EXPLANATION OF SIGNIFICANT DIFFERENCES
VELSICOL CHEMICAL CORPORATION SUPERFUND SITE
OPERABLE UNIT 1
SAINT LOUIS, MICHIGAN
EPA SITE ID: MID000722439

UNITED STATES ENVIRONMENTAL PROTECTION AGENCY

SEPTEMBER 2024

FIGURE 3
 Upgradient Slurry Wall Repair Area
 Velsicol Chemical Corporation Superfund Site
 St. Louis, Michigan

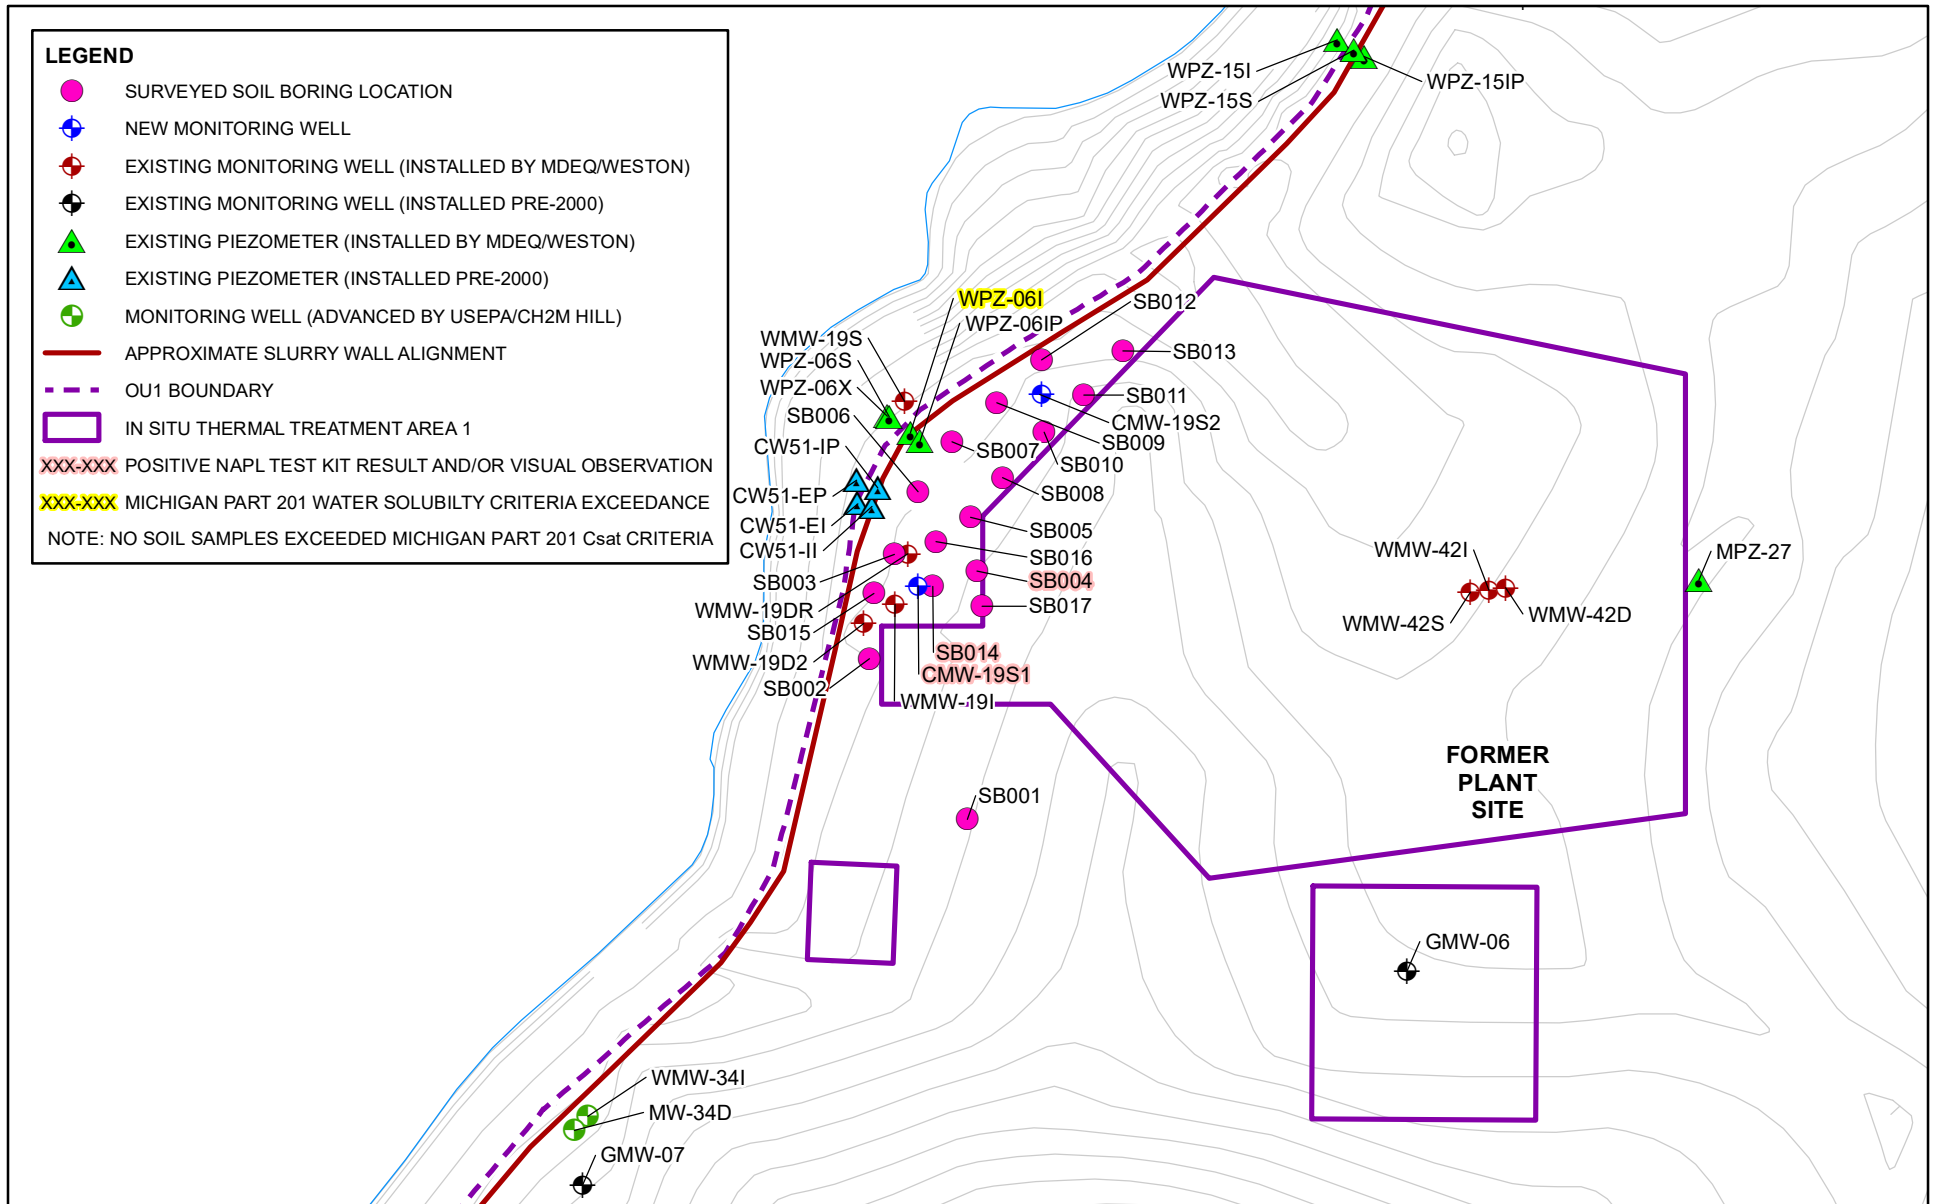
Surrounding the 20-foot breach is an area approximately 350-feet wide between CPZ-30 and CPZ-25 (Figure 3) reflecting substandard hydraulic performance. The substandard performance is defined in this area because inward hydraulic gradients (Appendix C) are observed in piezometer clusters CPZ-27-5 (immediately north of breach area) and CPZ-29 (immediately south of breach area). These inward gradients are likely caused by shallow groundwater inside the FPS discharging through the 20-foot breach, resulting in a depression of groundwater elevations near these locations and diminished localized mounding on the interior side of the slurry wall. The exterior piezometers are unaffected by this process and continue to be a hydraulic barrier. Figure 3 shows the 20-foot breach area and the 350-foot area that will be repaired.

Since a majority of the upgradient slurry wall is performing adequately, the 20-foot breach and surrounding 350-foot substandard performance area may be repaired in lieu of installing a steel sheet pile wall along the entire 3,100 linear foot upgradient alignment of the slurry wall. Various technologies are available for repair of the upgradient vertical barrier wall. With respect to repairing the current slurry wall versus installation of a new steel sheet pile vertical barrier wall, the upgradient slurry wall repair would be easier and quicker to implement, more effective long-term, and cost approximately one-twentieth what a new sheet pile wall would cost (see Table 5).

Upgradient Slurry Wall Hydraulic Conductivity Results
*Velsicol Chemical Corporation Superfund Site
 Saint Louis, Michigan*

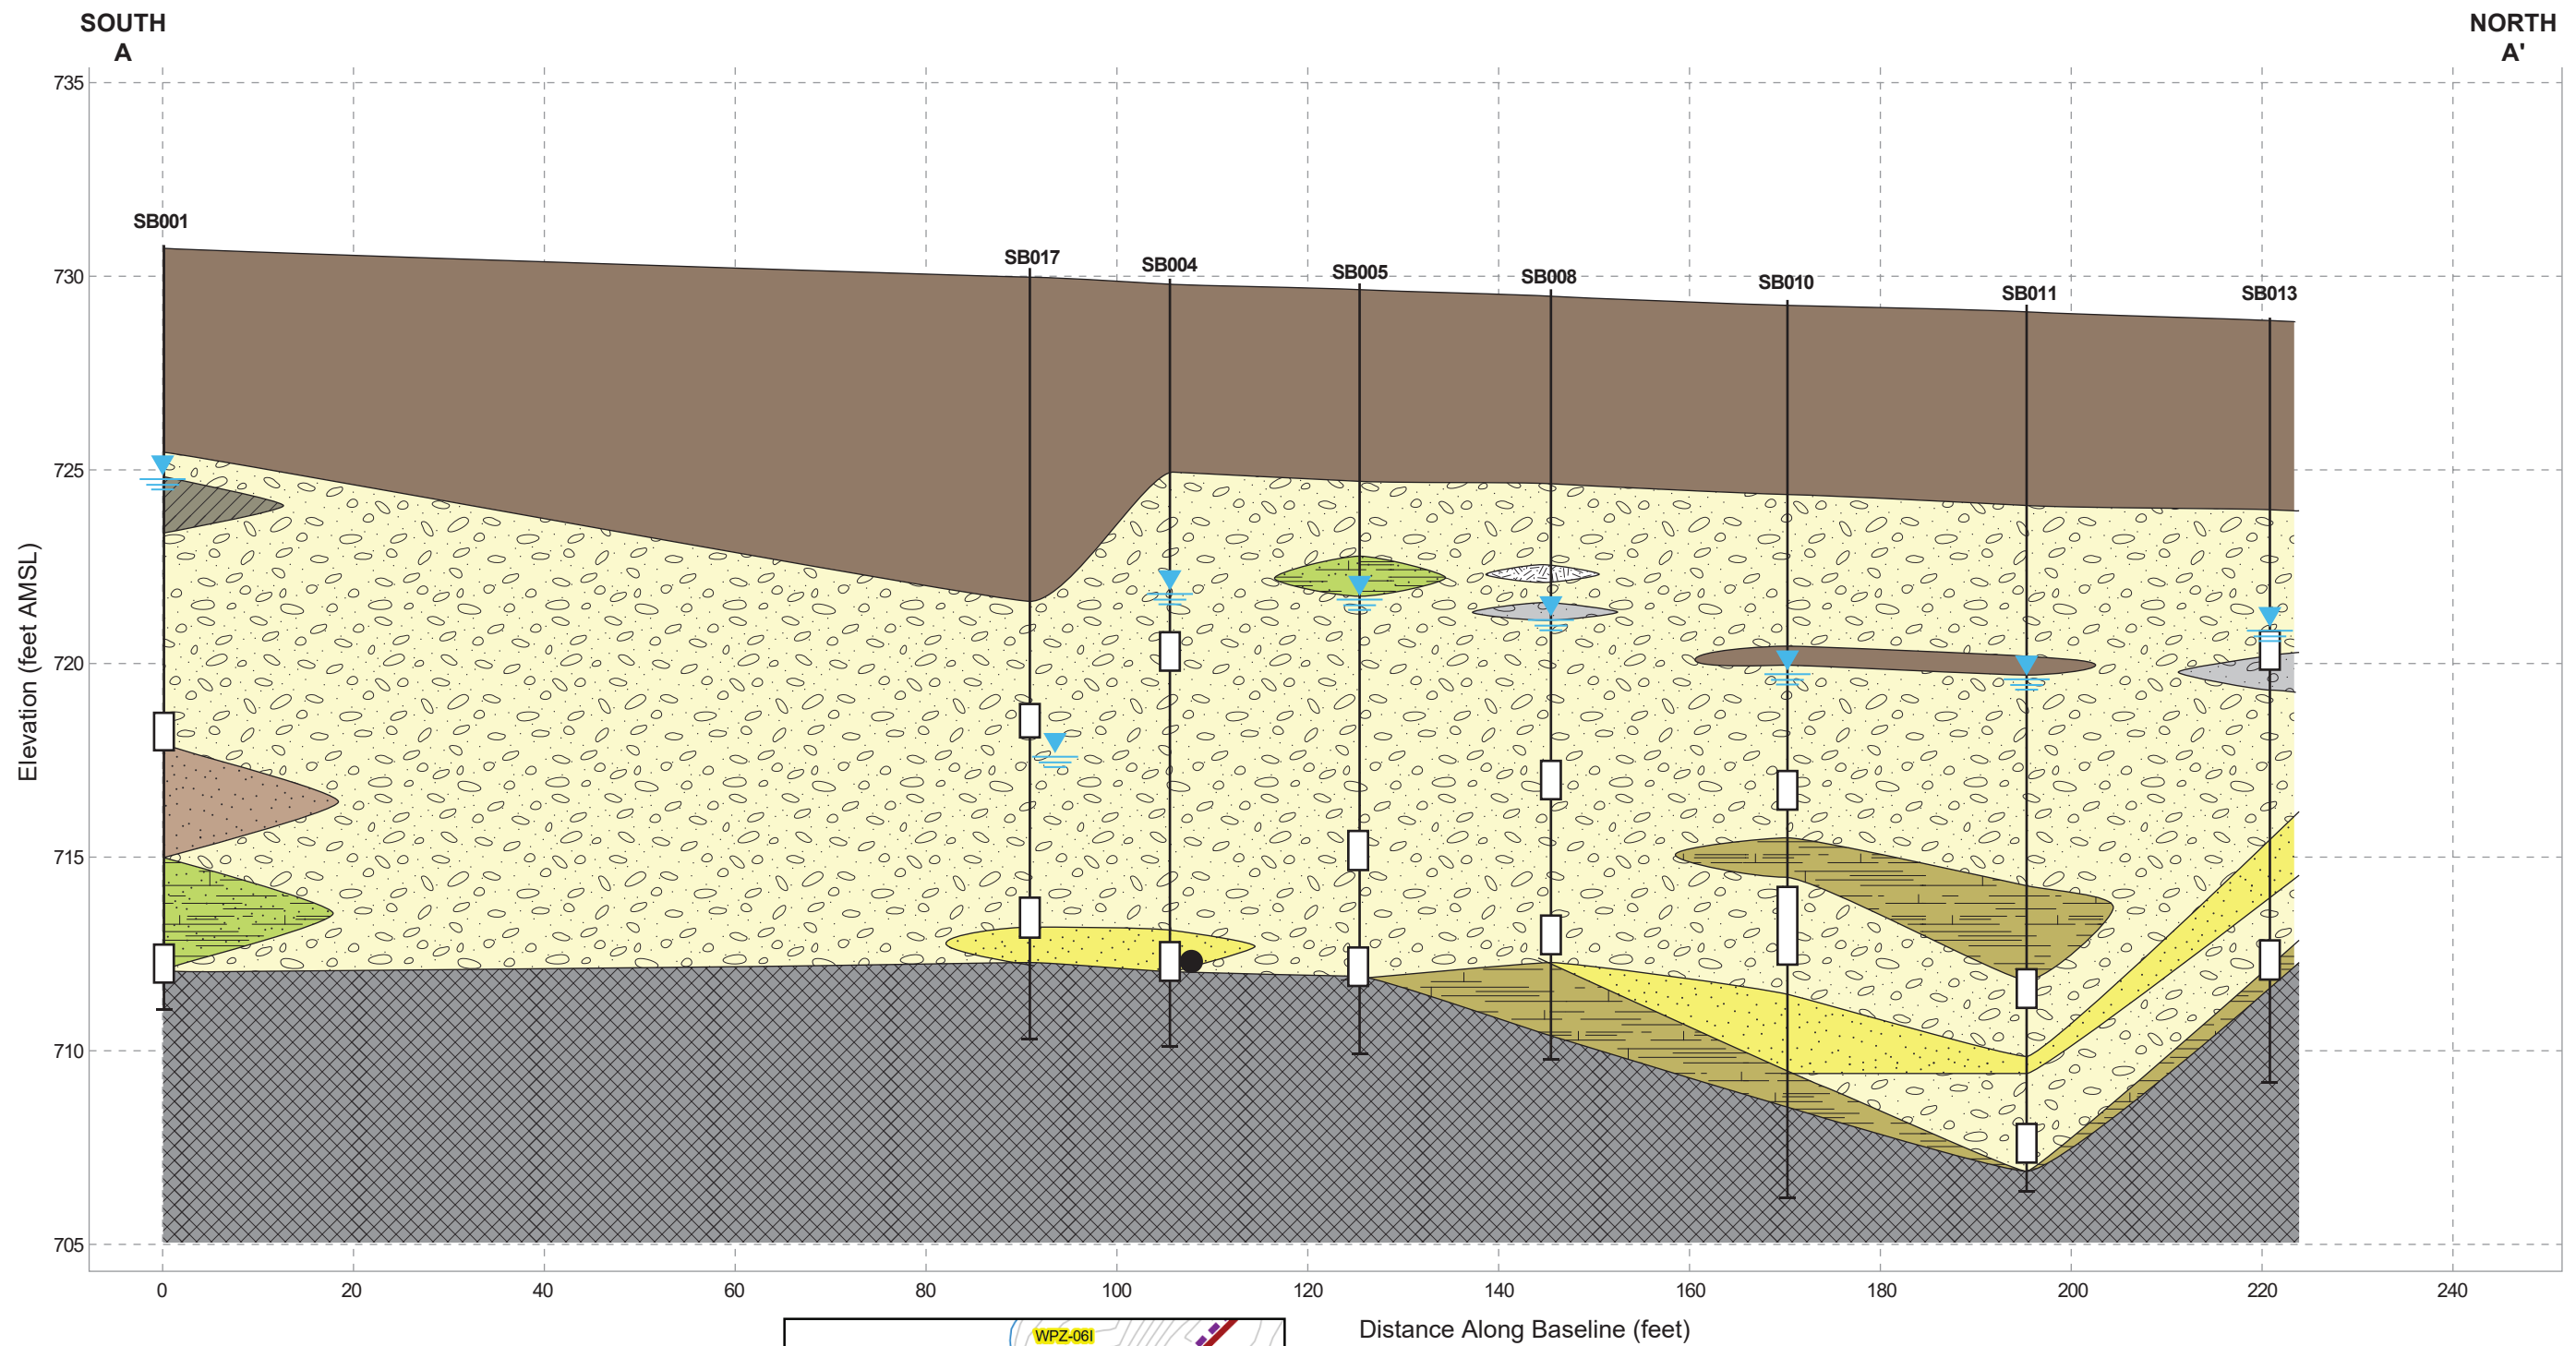
Upgradient Slurry Wall Hydraulic Conductivity Results, Appendix C-Figure 10. You show 11 samples collected. Five in 2019 and six in 2020. The Upgradient Slurry Wall is 3,100 feet long. That would mean the average distance between samples is 281 feet. All but one met or exceeded the recommended hydraulic conductivity requirement of 10^{-7} cm/s. The one that didn't came in at 7.5×10^{-6} cm/s. Very small numbers but a very big difference. 10^{-7} cm/s should take about 28.5 years to get through a properly built 3 foot bentonite slurry wall. 10^{-6} cm/s, 138 days. Knowing that we have some very poorly constructed slurry walls surrounding the site and that NAPL and other contaminants can destroy a bentonite slurry wall are present and guilty, it would seem not enough samples were taken. What does EPA think is an appropriate spacing for detecting leaks and verifying the hydraulic conductivity of a slurry wall? Please support your response with field-based evidence or research.
